**DENDROBIUM MINE - PLAN FOR THE FUTURE:  
COAL FOR STEELMAKING**

**AMENDMENT REPORT  
AUGUST 2020**

**Disturbance Areas (East)**  
**Dendrobium Mine - Plan for the Future:**  
**Coal for Steelmaking - Biodiversity Assessment**

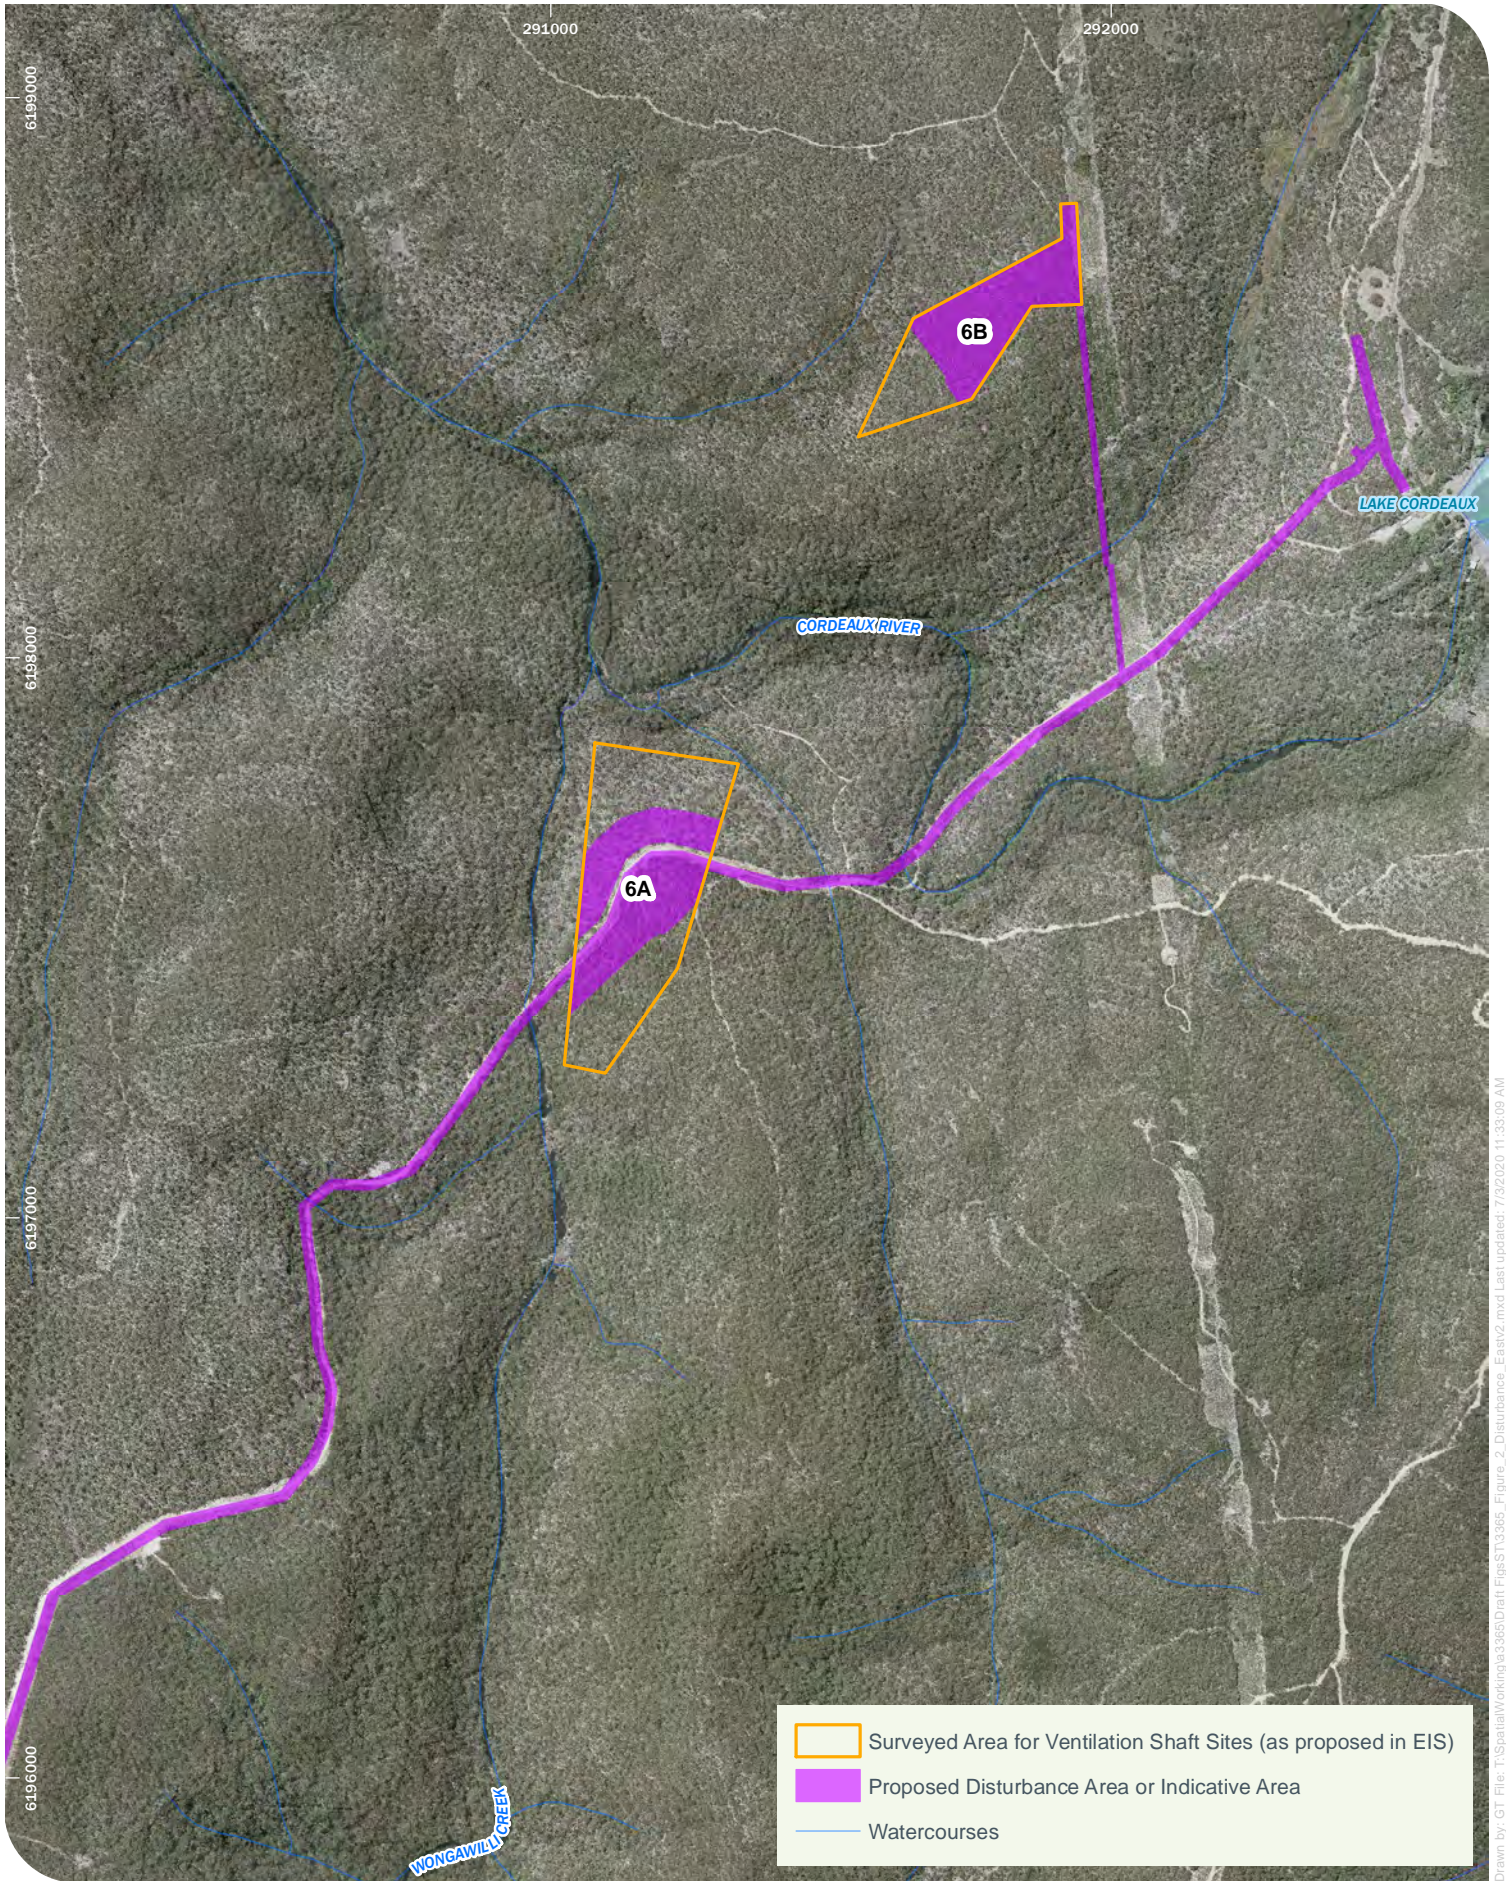
The ETL concept design originates at a connection point from an existing Endeavour Energy transmission line located approximately 200 m north west of the Cordeaux Dam Wall. (Figure 2). This connection point is being designed in consultation with Endeavour Energy.

Note that the ETL design for the section from Fire Trail 6 to Ventilation Shaft Site 6B is proposed to be trenched and cabled underground within the 330 kV Transgrid easement south of the creek. This is to avoid vegetation clearing (Figure 2).
